RECORD DRAWING
THESE PLANS HAVE BEEN REVISED TO REFLECT CHANGES AS INDICATED BY CONSTRUCTION RECORDS
11-16-06

LA MADELEINE RESTAURANT
ROCKWALL CROSSING
CHANNEL PLAN & PROFILE

SHEET C-5.2
OF 15 SHEETS

TRANSITION DETAIL

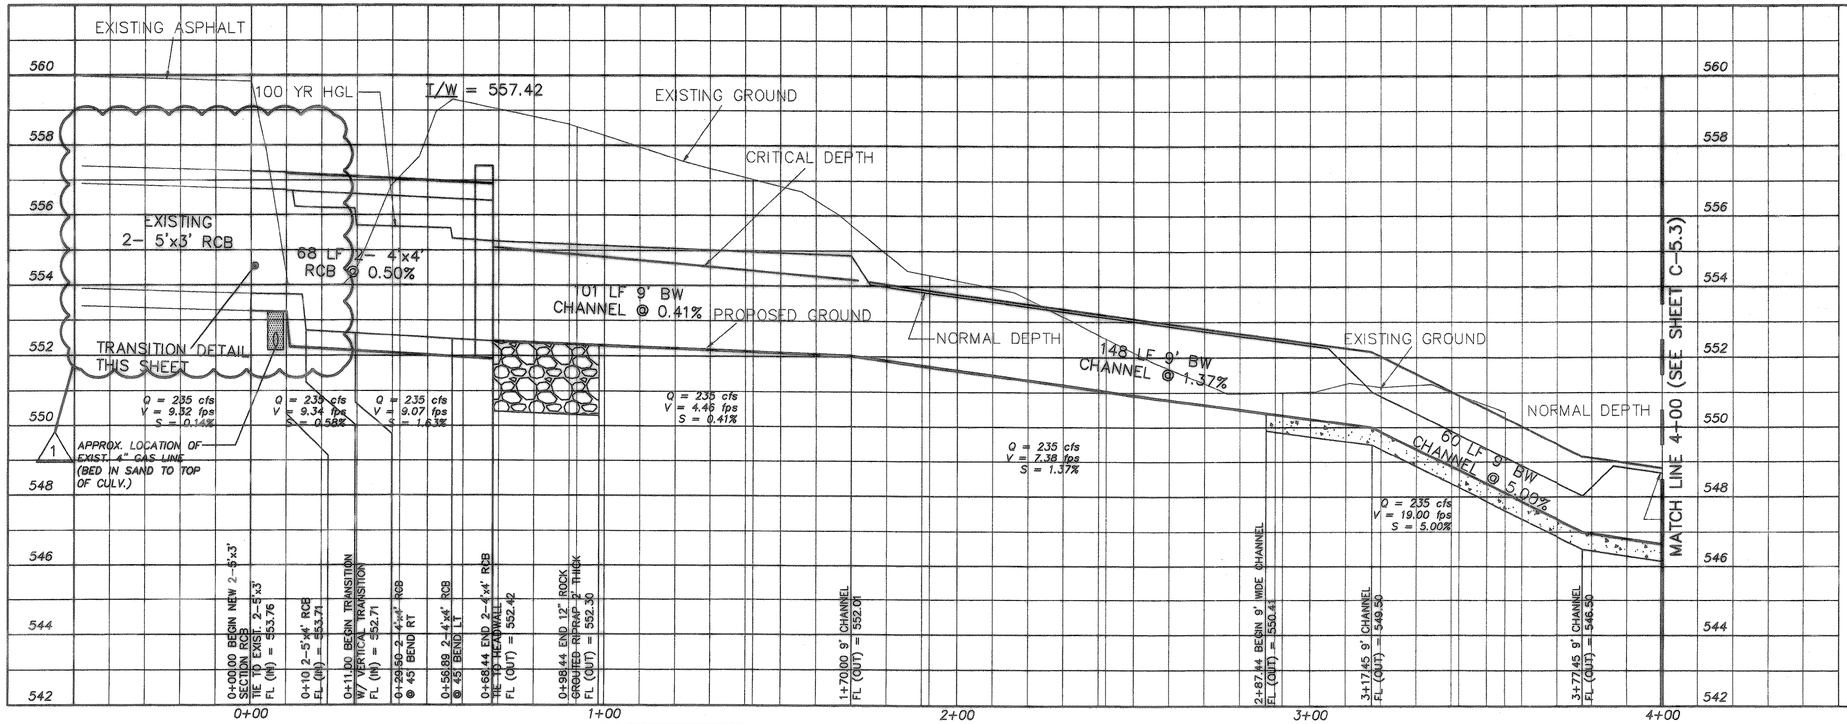
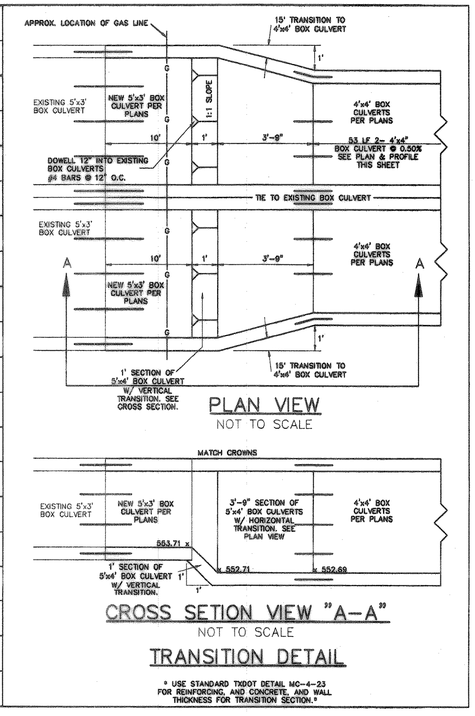
REV	DATE	BY	DESCRIPTION
1	08/21/2006	ROC	ADD TRANSITIONS TO CULVERTS, TO ADJUST FOR SIZE DIFFERENCES. SEE DETAIL THIS SHEET.

* USE STANDARD TXDOT DETAIL MC-4-23 FOR REINFORCING, AND CONCRETE, AND WALL THICKNESS FOR TRANSITION SECTION.*
